Product Change Notice (PCN)

PCN Number: **PCN-0450984R-01**

Product(s) Affected: SJ1-3543N & SJ1-3545N

OLD DETAIL / IMAGE	NEW CUI DEVICES DETAIL / IMAGE

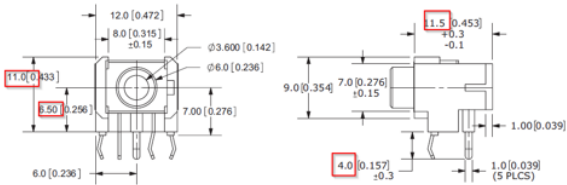
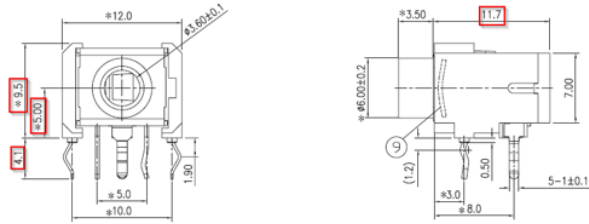
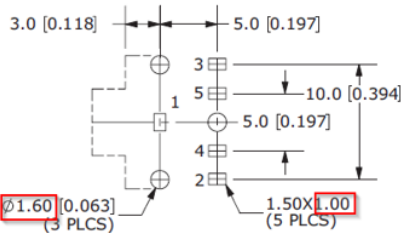
1. New part is 1.5mm shorter and is 0.2mm longer
2. PCB Recommendation has differed

<p>PCB LAYOUT TOP VIEW</p>	 <p>Recommended PCB Layout Top View</p>
